Our Ref: S3171/GBASS_TBT/25/003Lg

31 December 2025

**Proposed 'Government Use' (GBA Air Quality Laboratory and
Meteorological Monitoring Supersite and Associated Filling of Land)
in "Green Belt" Zone and Area shown as 'Road',
Government Land in D.D.129, Deep Bay Road, Tsim Bei Tsui,
Yuen Long, New Territories
(Section 16 Planning Application No. A/YL-LFS/592)
- Supplementary Information -**

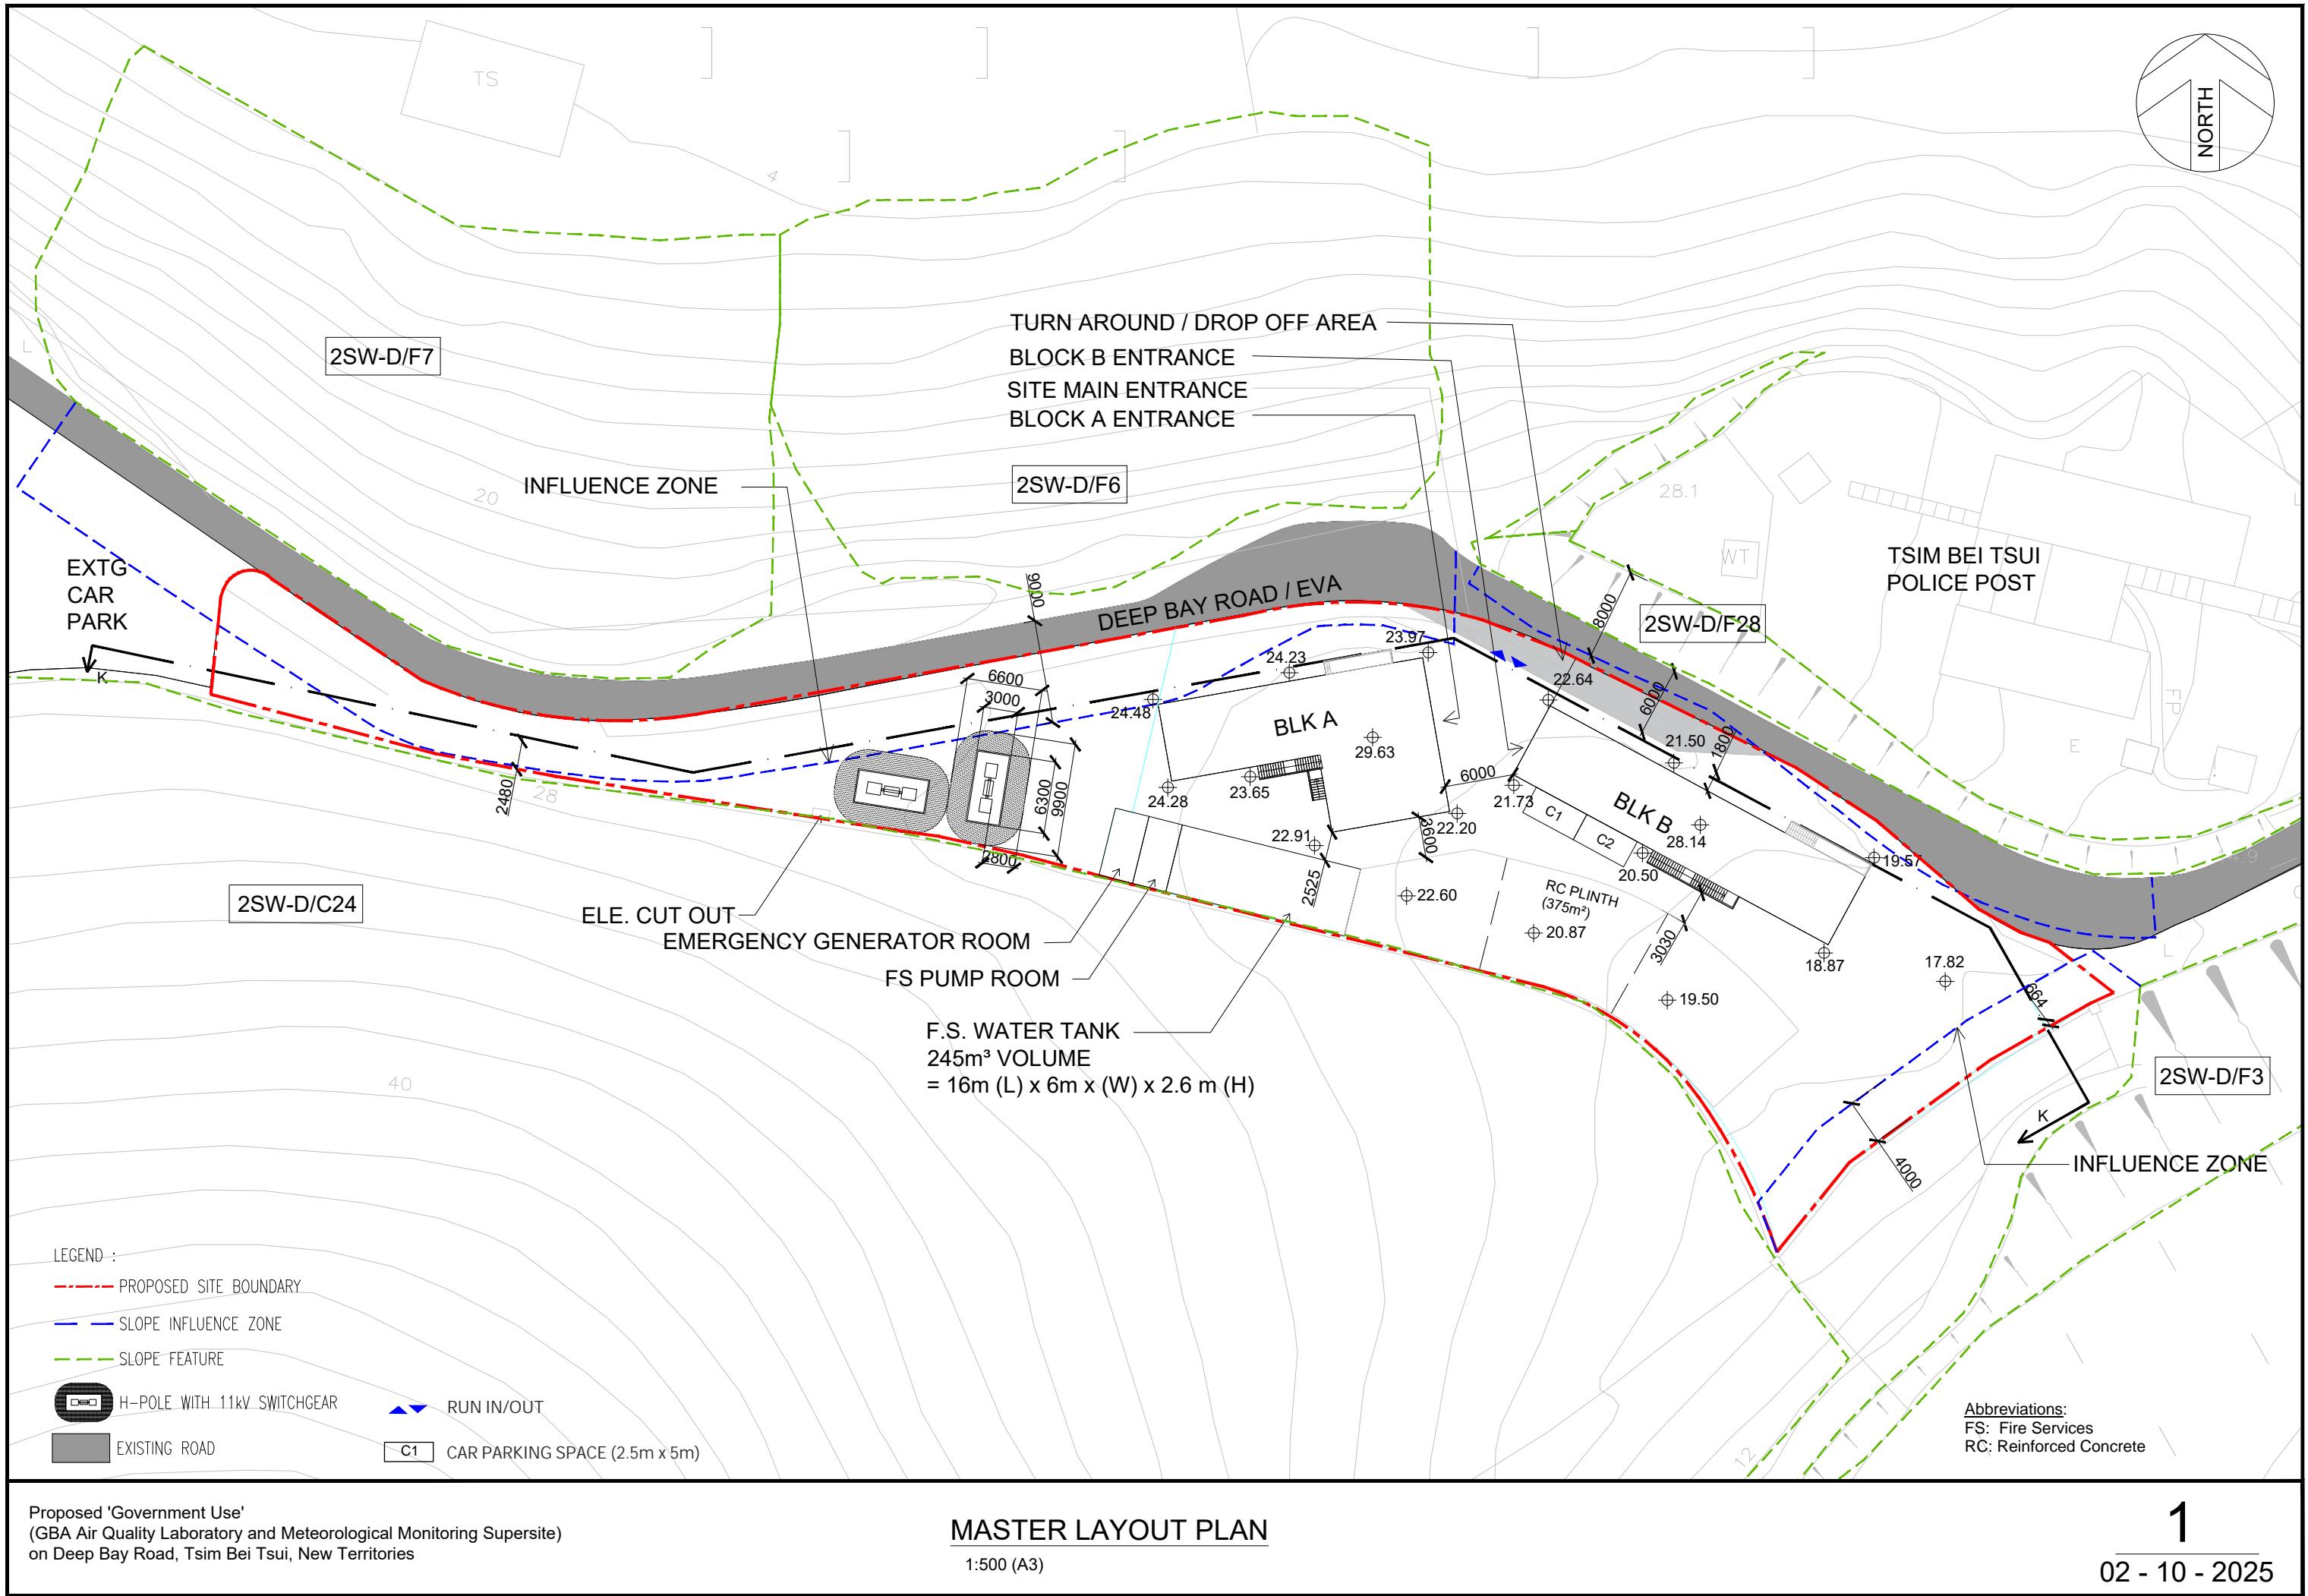
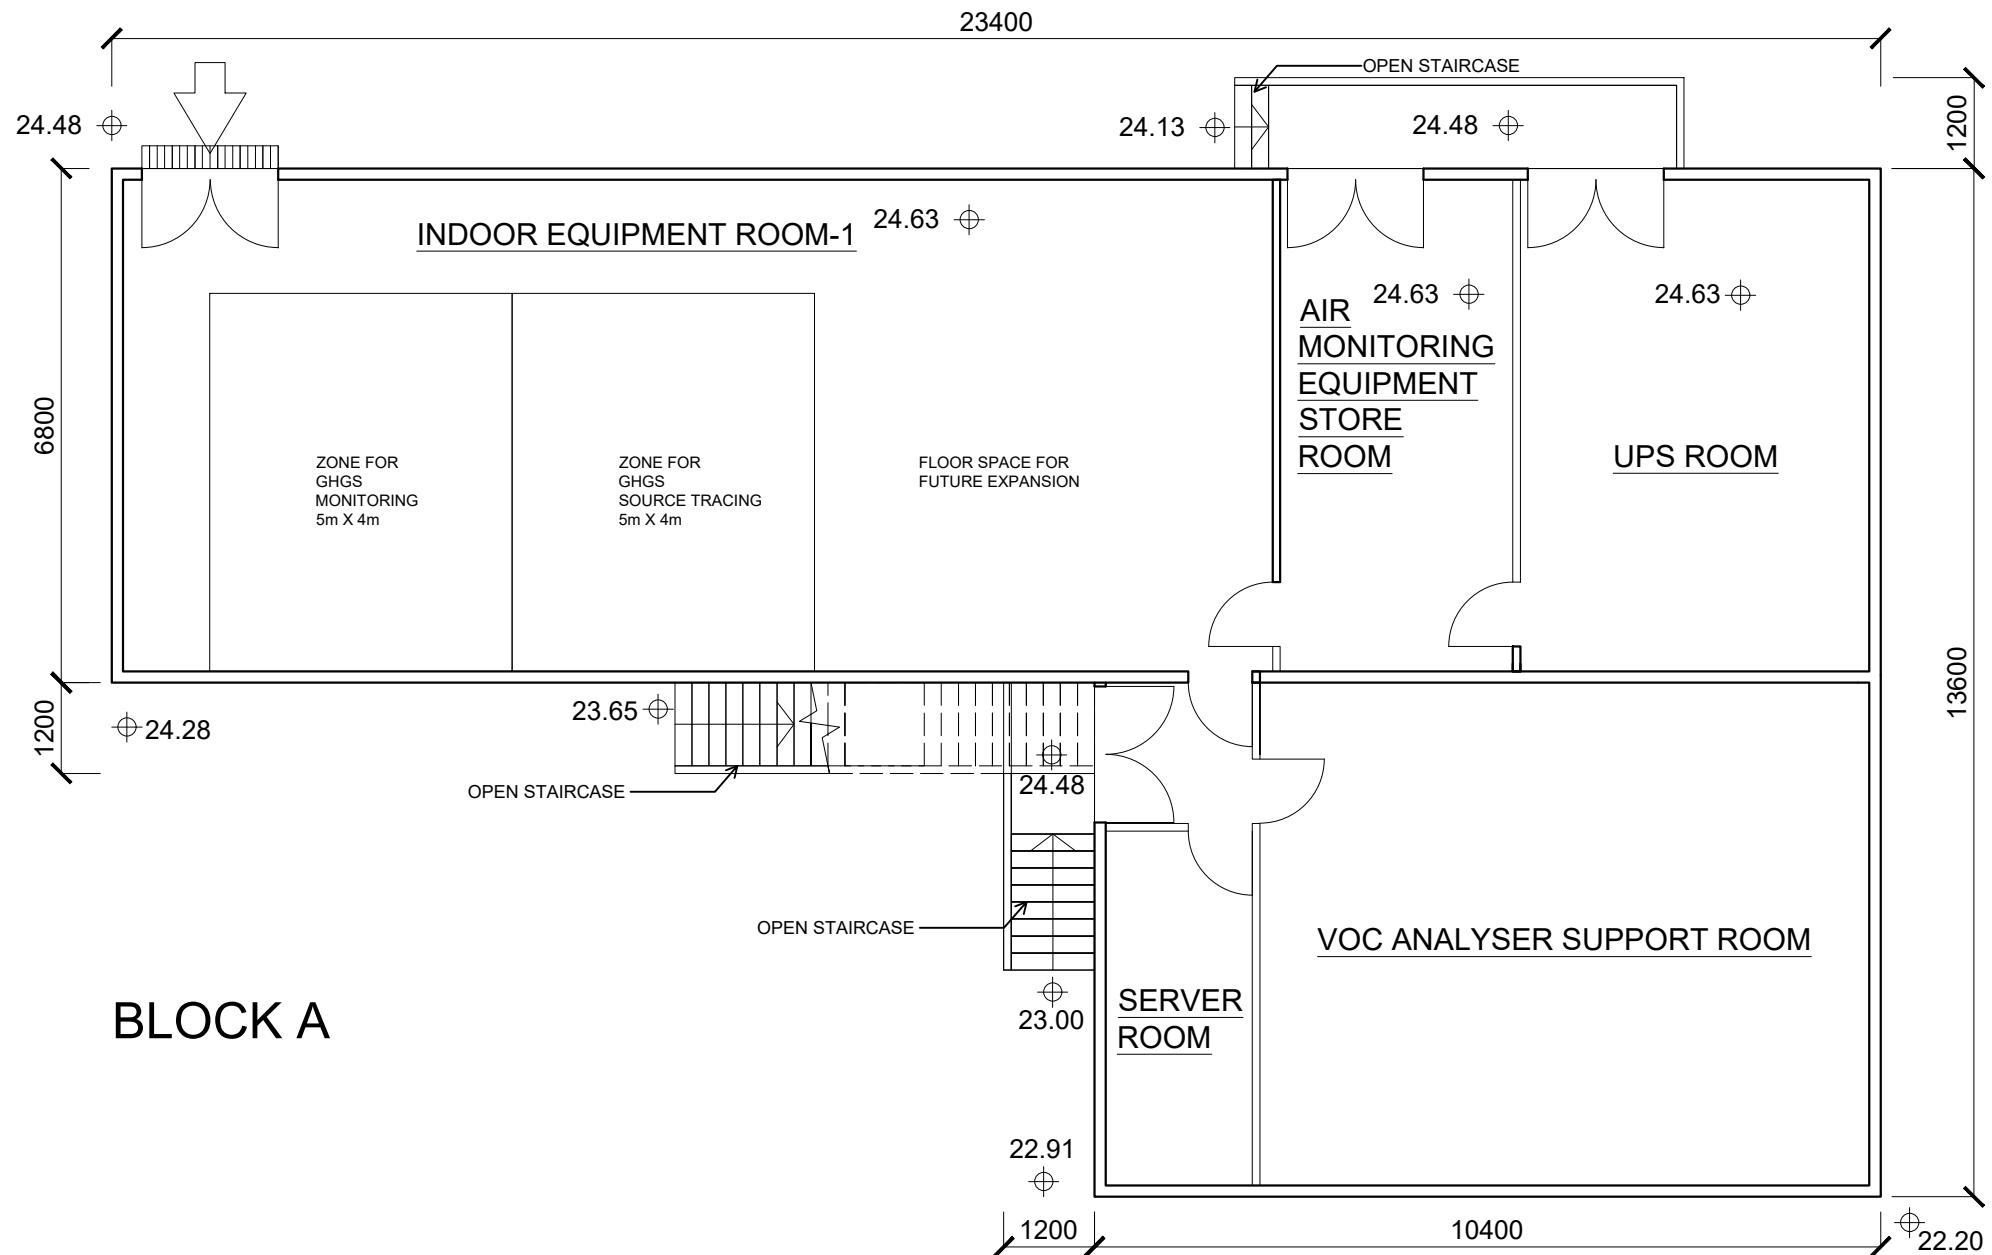
For clarification purpose, please find attached the replacement page of the Application Form (with revised proposed use, area and depth of filling) (Pg. 7, 10 & 14), replacement pages of Planning Statement (with the full phrases of the abbreviations) (Pgs. 4 & 14), revised Master Layout Plan (with revised legend) as well as revised Block Layout Plans (with abbreviations). Please also find attached an additional Plan showing the extent of filling within the Site.

Plan of Extent of Land Filling

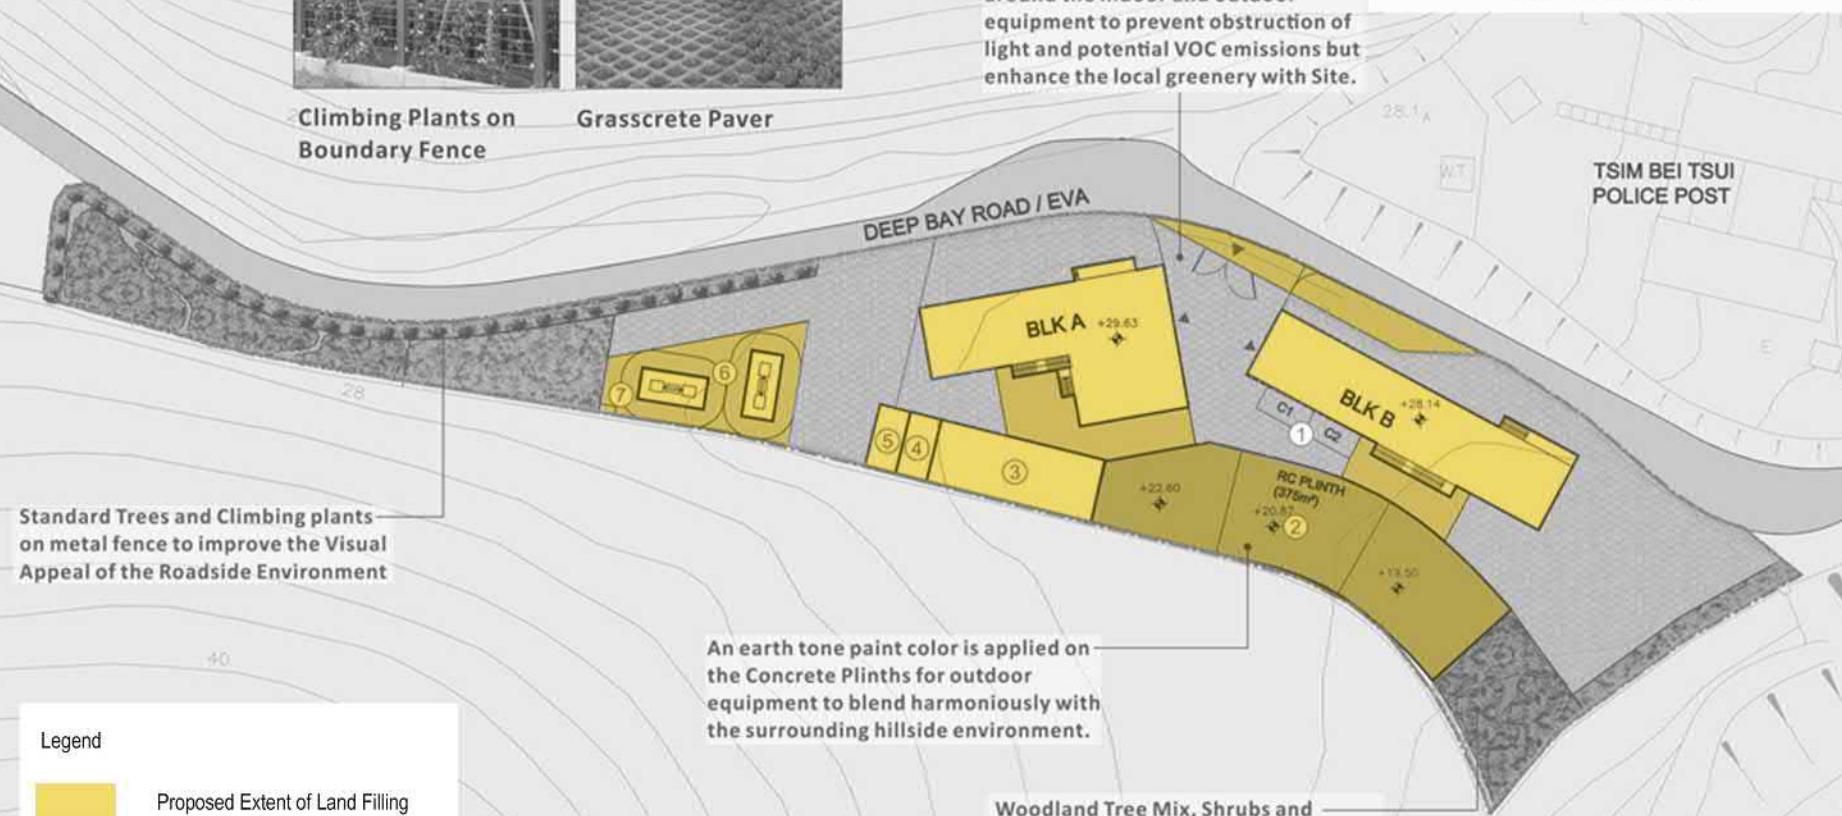
Please note that the proposed extent of land filling is indicative only. It is proposed to apply pad footing foundation design beneath the elevated structural support of the two blocks, such that the total area of land filling / paving would be reduced.
